**ADDENDUM NO. 1 -** Distributed via email and posted on the City of Burlingame website at: www.burlingame.org/washingtonplayground

Washington Park Playground, Sports Court, & Picnic Area - City Project Number 85670

Addendum Issue Date: 04/18/2019

**L6.1**

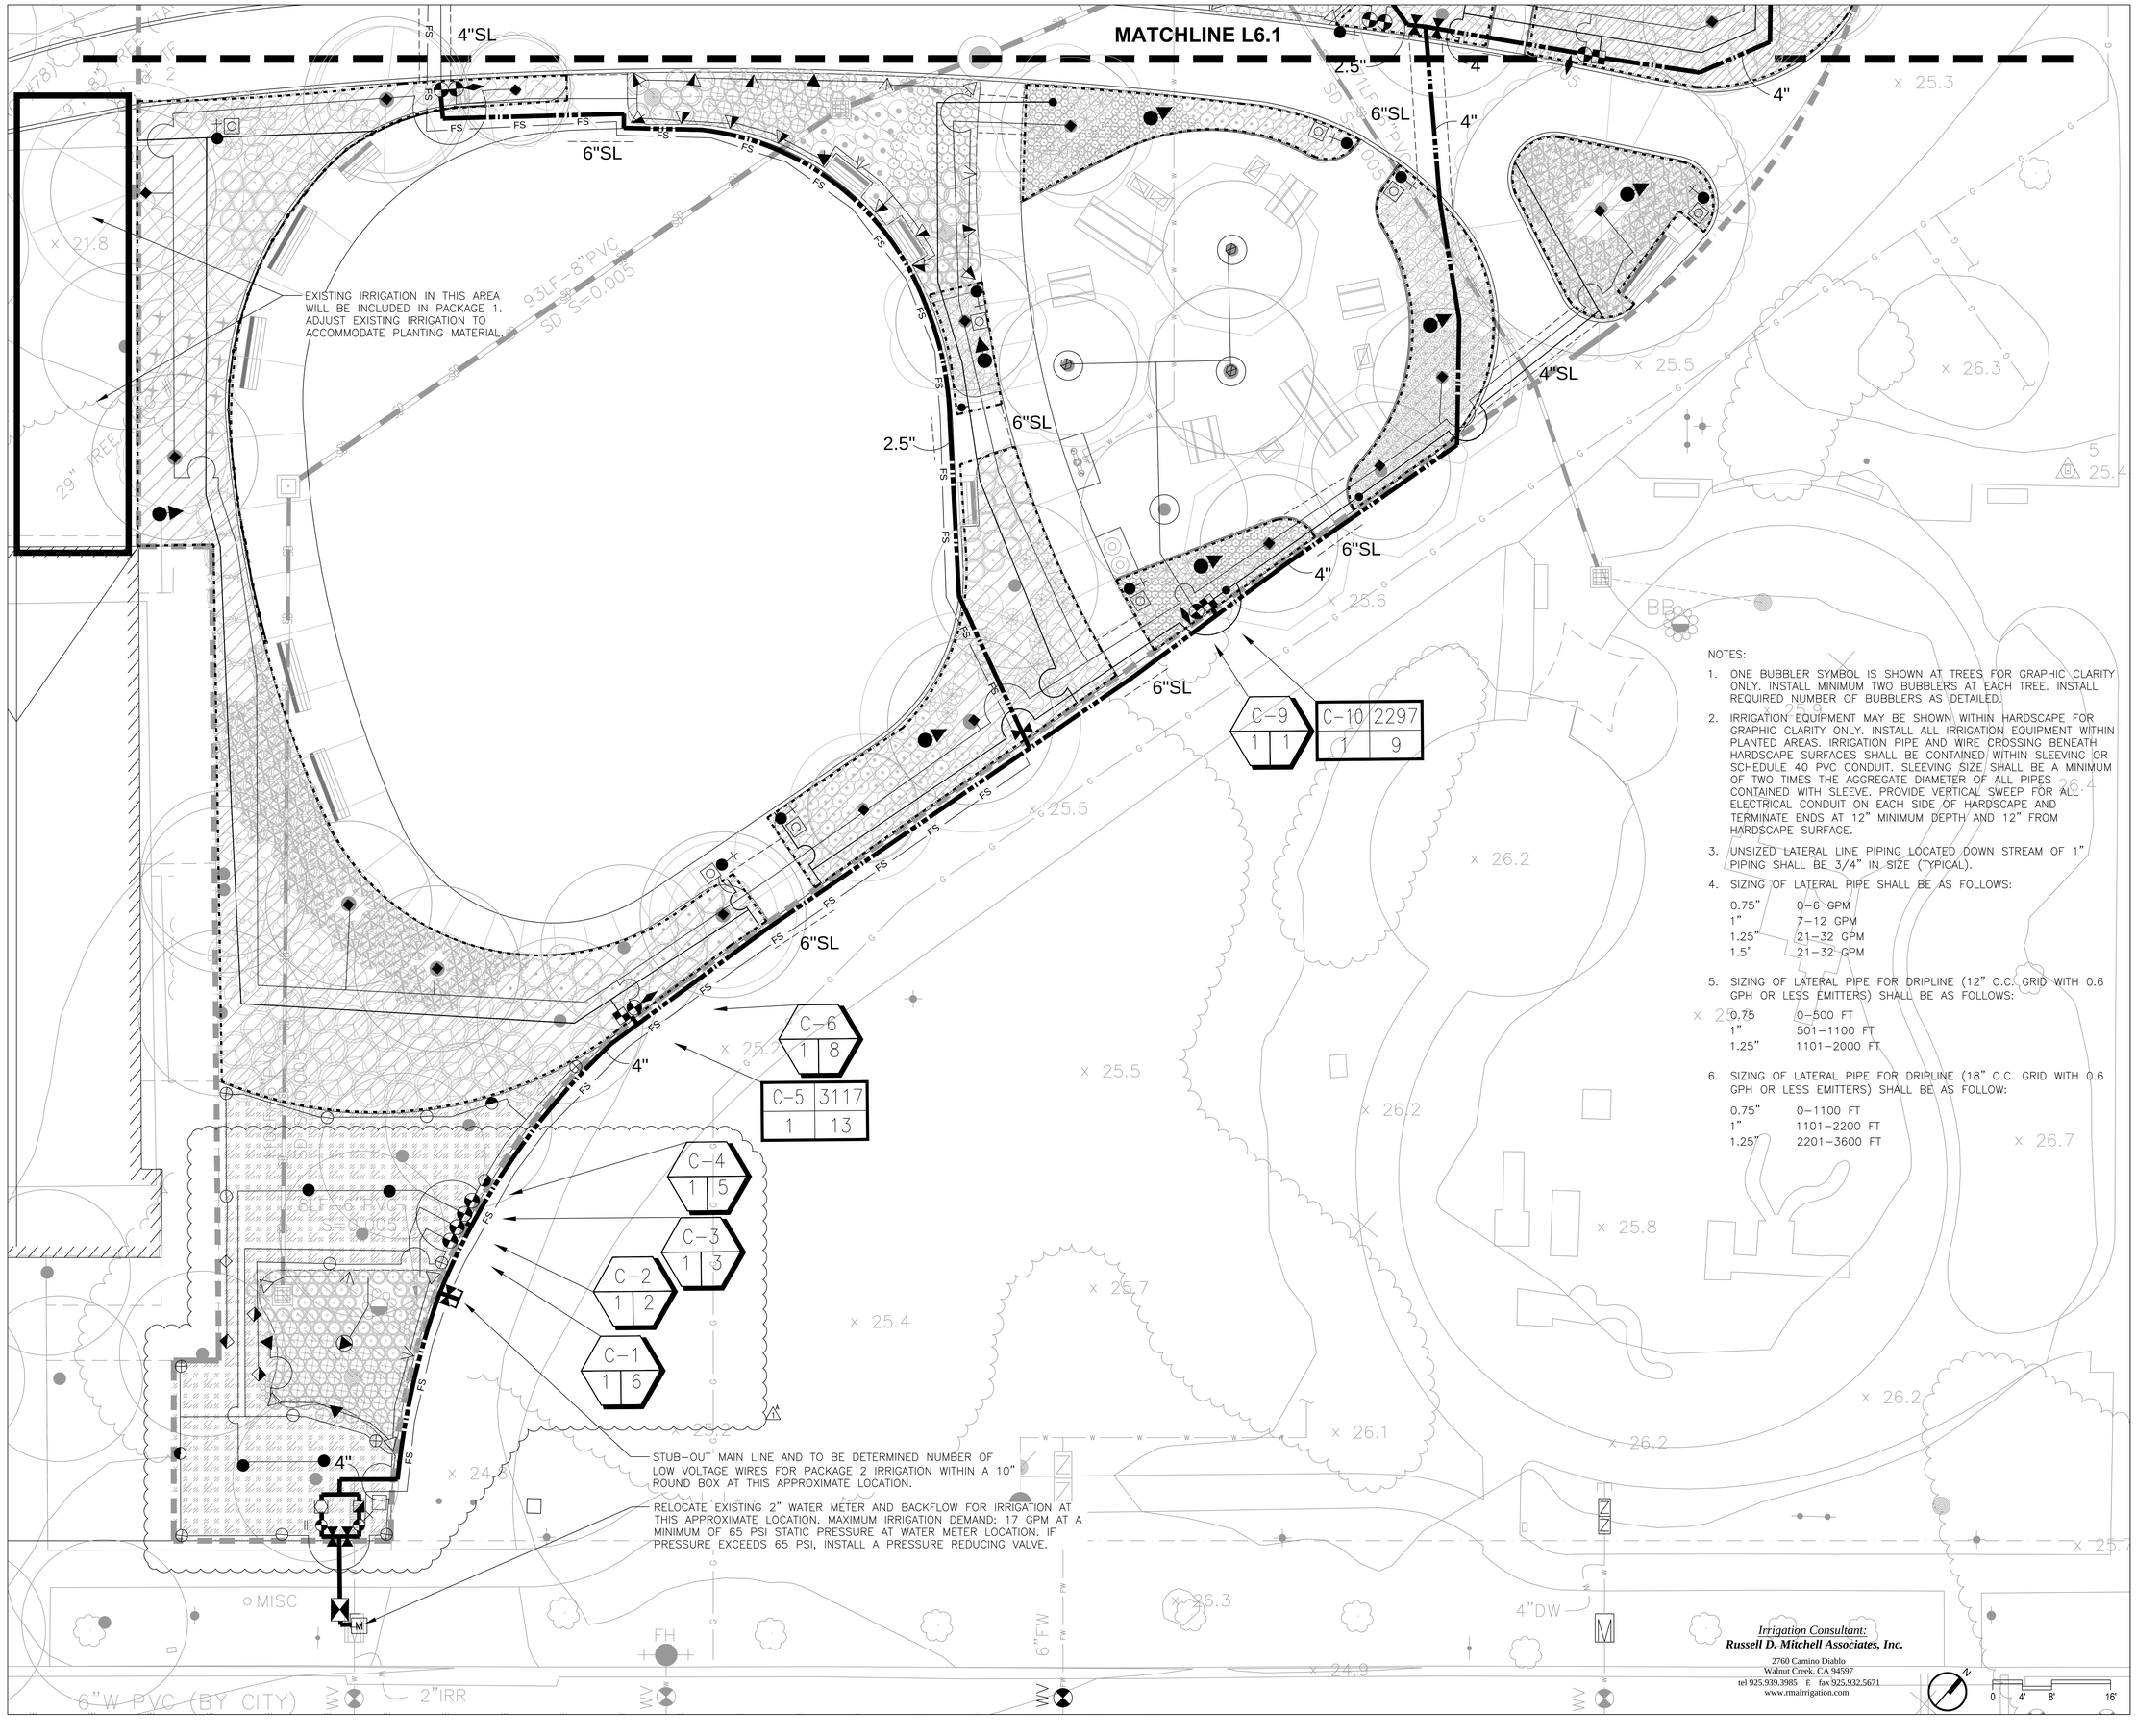
32. **Sheet L6.1:** Revised irrigation layout for expanded picnic area and reduced turf area south of multi-use court.
33. **Sheet L6.2:** Revised irrigation required an additional valve.
